# Technical comments on the zero-emission building definition in EPBD recast proposal

**JAREK KURNITSKI**  
REHVA Technology and  
Research Committee,  
Tallinn University of  
Technology  
jarek.kurnitski@taltech.ee

The definition of the zero-emission building (ZEB) is a major topic in the EPBD recast proposal. It sets requirements and threshold values for primary and renewable energy impacting the installation of technical building systems. ZEB also defines class A of the Energy Performance Certificates (EPC).

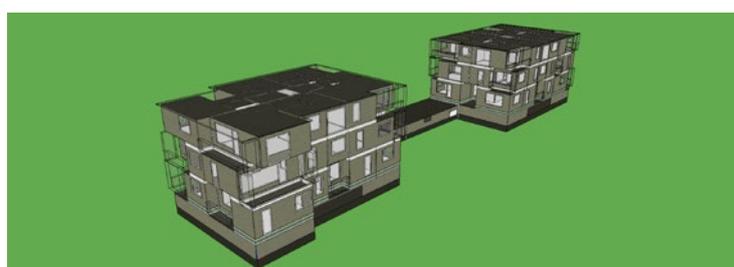
*It is not defined what happens if one of these definitions is not fulfilled. Which class the building*

*will be if not all requirements are reached? It is needed to define a class A for the EPC.*
